QUALITY ASSURANCE - NONCONFORMANCE REPORT

NCR #118

Contract No. 04-0120E4
04-SF-80-13.4, 13.8
SAS T1 & E2 Foundations
SFOBB-ESSSP

Subject: Response to Submittal No. 885, Revision No. 00 (Oregon Iron Works Response to NCR Generated by State Letter 1808)

SECTION 'A'
 TYPICAL CONNECTION DETAIL
 SUPPORT BEAM TO PILE SLEEVE

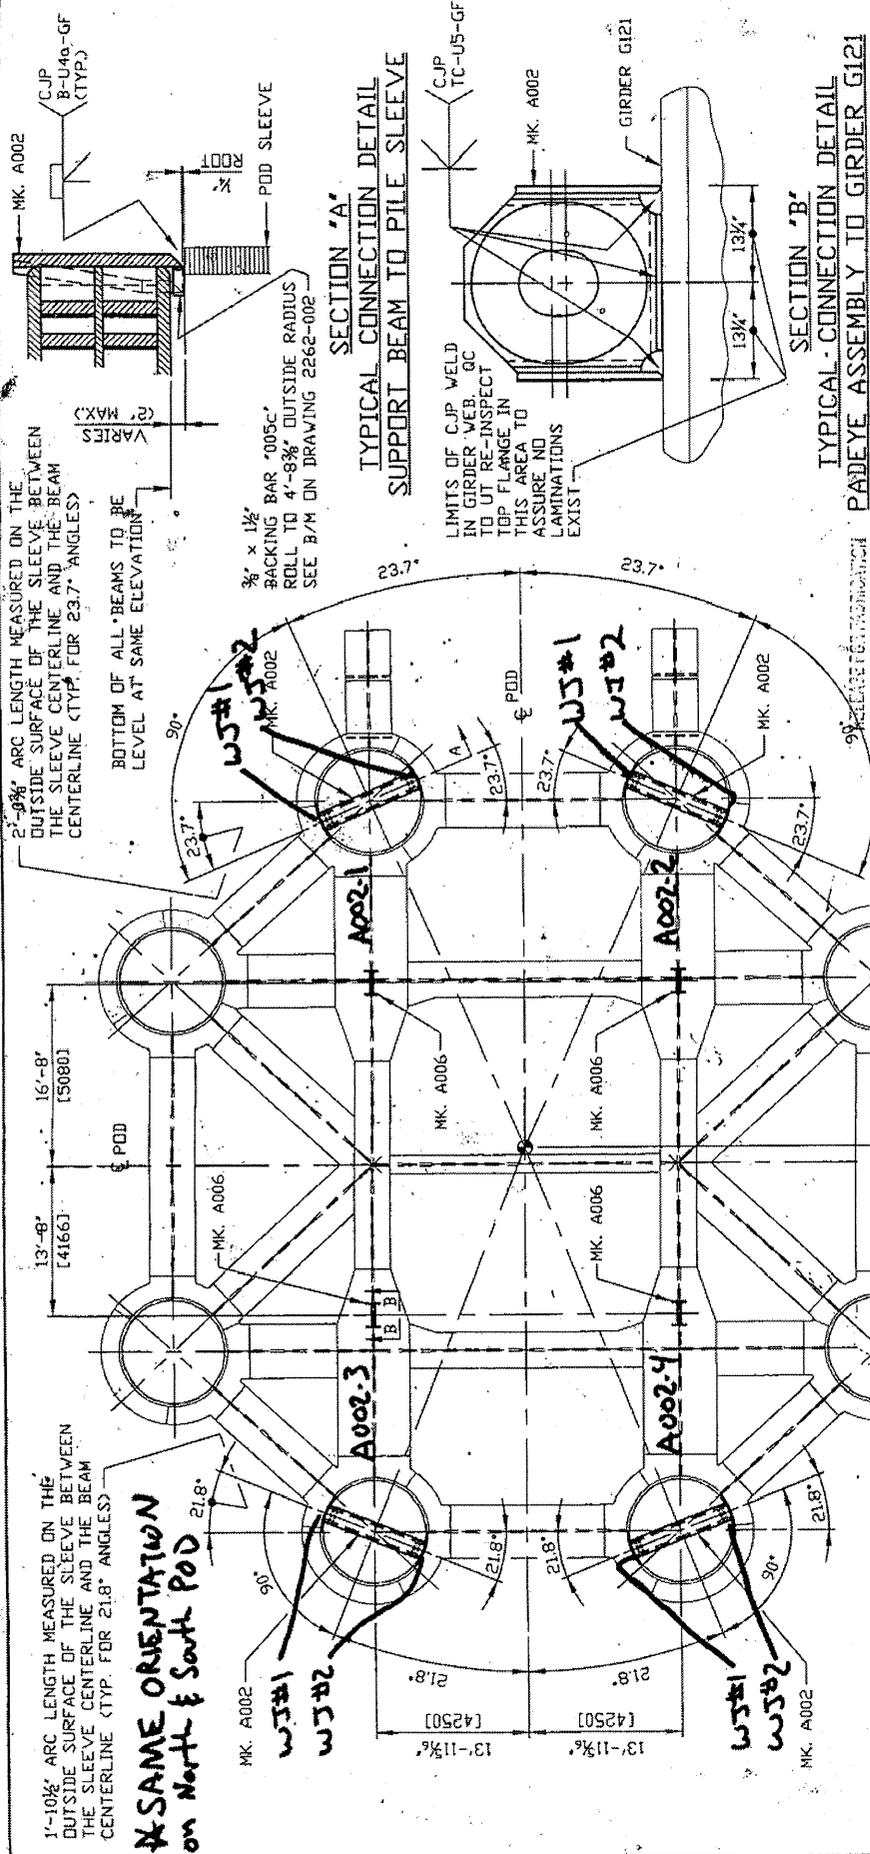
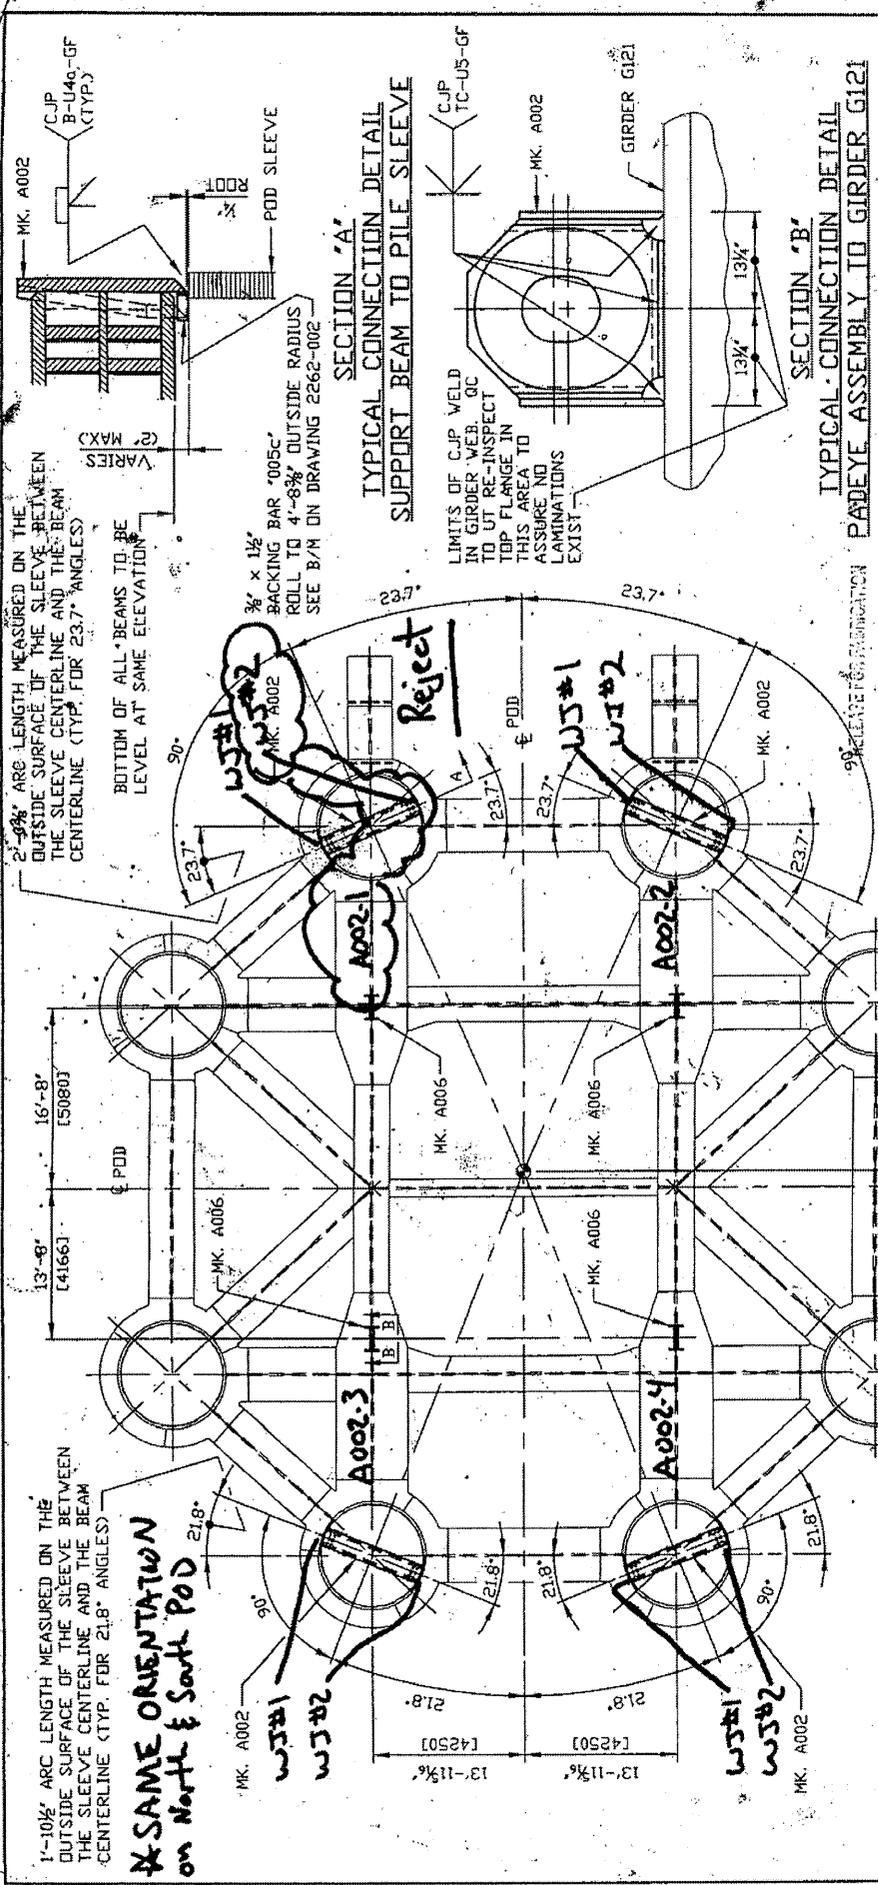
Description of Non-Conformance: Oregon Iron Works Quality Control Department allowed a second time repair of the Support Beam to Pile Sleeve 306-1 complete joint penetration weld on the G111 side of the support, without the Engineer's approval.

Reject

LIMITS OF CJP WELD IN GIRDER WEB, QC TO UT RE-INSPECT TOP FLANGE IN THIS AREA TO ASSURE NO LAMINATIONS EXIST

10. NCR 118 was issued to document the Contractor proceeding with second time repairs on the weld connecting the support beam to Pile Sleeve 306-1. METS understands that this issue occurred as a result of the Contractor's decision to proceed in order to meet deadlines in their schedule. METS personnel have discussed this issue with the KFM and OIW Quality Control Managers and have reminded them of their contractual requirement to receive Engineer approval before proceeding with CWRs. METS does not expect this to be an issue with OIW in the future. Additionally, OIW has included the NDT reports of the repairs made to the above referenced weld and the results appear to be acceptable. METS considers this NCR to be resolved at this time.

Oregon Iron Works, Inc. (OIW) has received State Letter 1808, which documents a non-conformance for performing a Critical Weld Repair (CWR) prior to receiving Engineer's Approval on the PS-306-1 to G-111 support beam.

All required QC Inspections have been completed on this weld and the results are attached.
